## ABS WIRING UPDATE PROCEDURE

**WARNING:** Always follow all Federal, State, And Local and Shop safety standards and use proper safety equipment when performing these procedures. Observe all safety precautions to secure the bus from rolling. **NOTE:** This wiring update procedure is **ONLY** applicable to buses with cab mounted “D” version ABS ECU’s.

Stoneridge Instrument Cluster ABS  
Malfunction Indicator Noncompliance

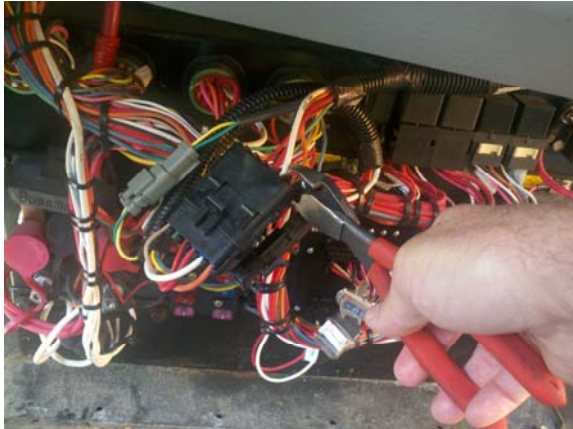
4. Locate connector C504 in PDU (detail shown below). Cut and remove connector C504 from the PDU and ABS harness.

5. Splice each circuit from previous step to the corresponding circuit. Use appropriate terminal as listed below.

Remove two “C504” connectors and splice each circuit to the corresponding circuit.

“ABS LGT”, “ABS ACTIVE”, circuit use terminal # 00005840.

“ABS GND”, “ABS BATT”, “MOD PUMP BATT”, circuit use terminal # 0036508.

“ABS IGN” circuit use terminal # 00036507.

C504	
ABS IGN (OR)	>A>	ABS IGN (OR)
ABS GND (WH)	>B>	ABS GND (WH)
ABS BAT (RD)	>C>	ABS BAT (RD)
MOD PMP BAT (RD)	>D>	MOD PMP BAT (RD)
ABS LGT (GN)	>E>	ABS LGT (TN)
ABS ACTIVE + (GN)	>F>	ABS ACTIVE + (TN)
